ADDENDUM NO. 1

NEW ADDITION FOR
KETTERING SEVENTH-DAY ADVENTIST CHURCH
3939 Stonebridge Road
Kettering Ohio

June 10, 2019

34 HEAD DOOR 102A
SCALE: 3" = 1'-0"

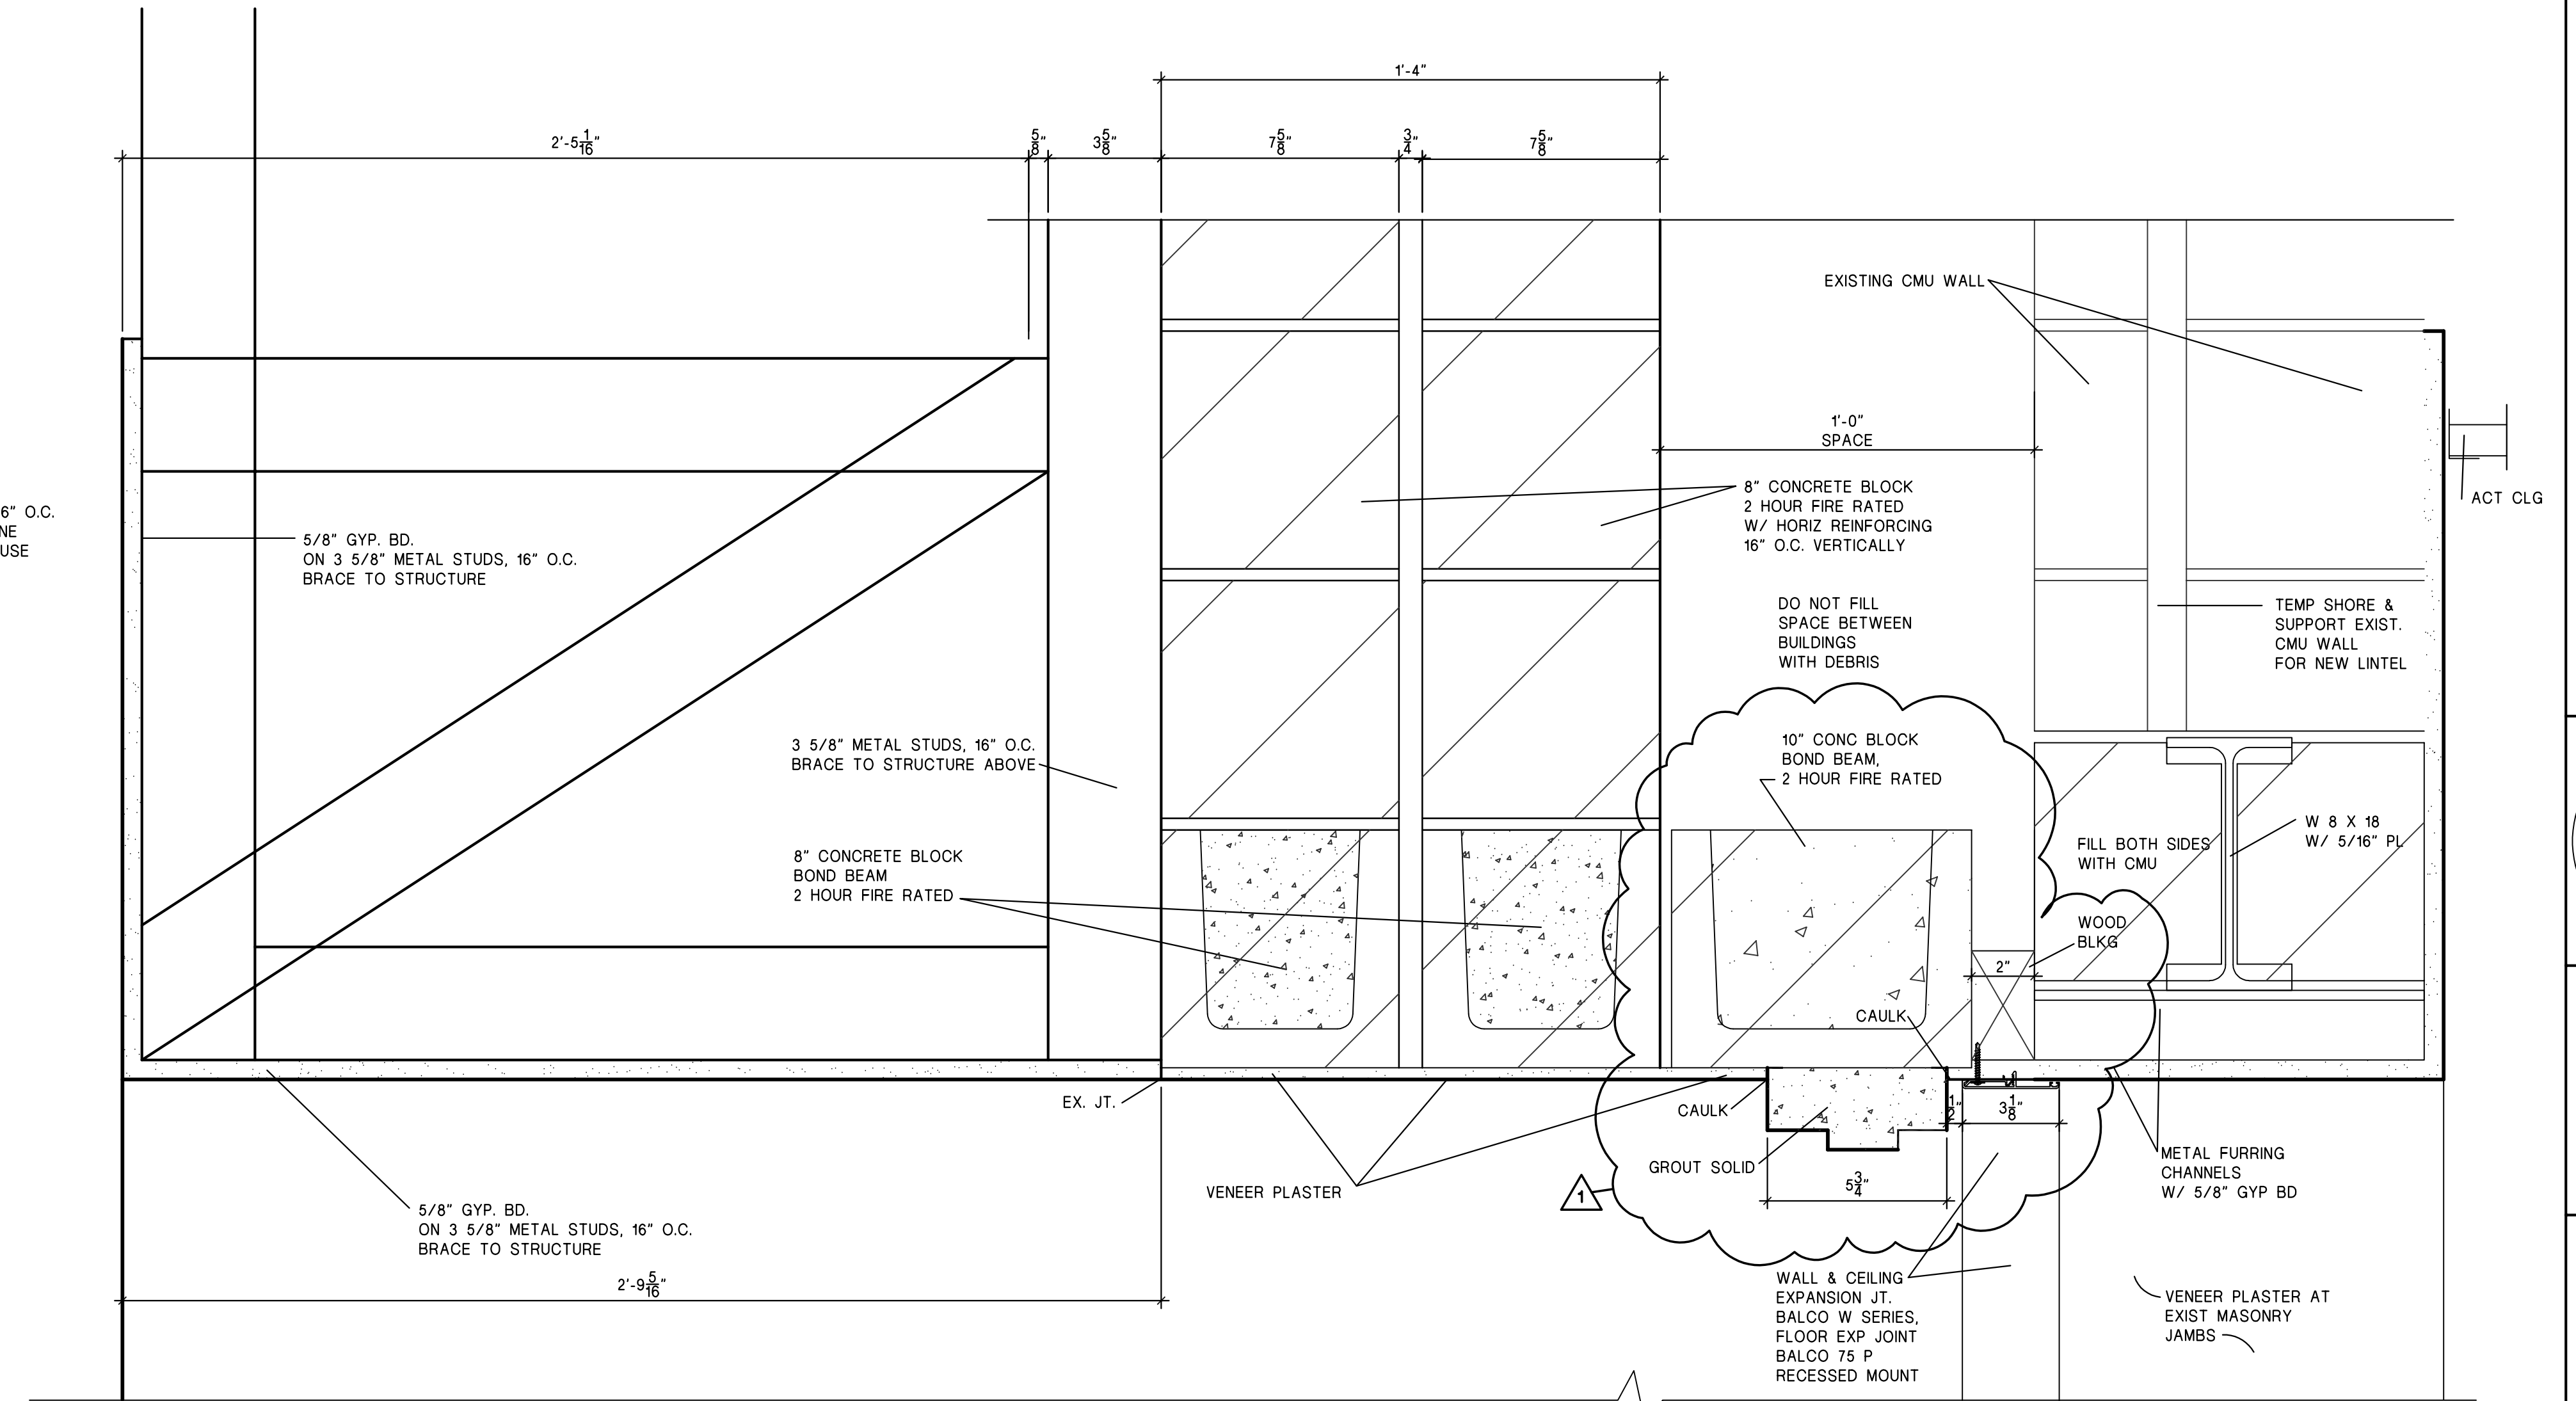
1. Sheet A 6.5 Revise the 10" bond beam to the position shown for door head 34
2. Sheet A 3.4 Detail 12. At the 2nd floor, revise the height of the thin brick from 9'- 4" to 10'- 0" above the finish 2nd floor elevation at the interior, classroom side of the 2nd floor.

ITEM 1 Revise 10" bond beam position at door head 34
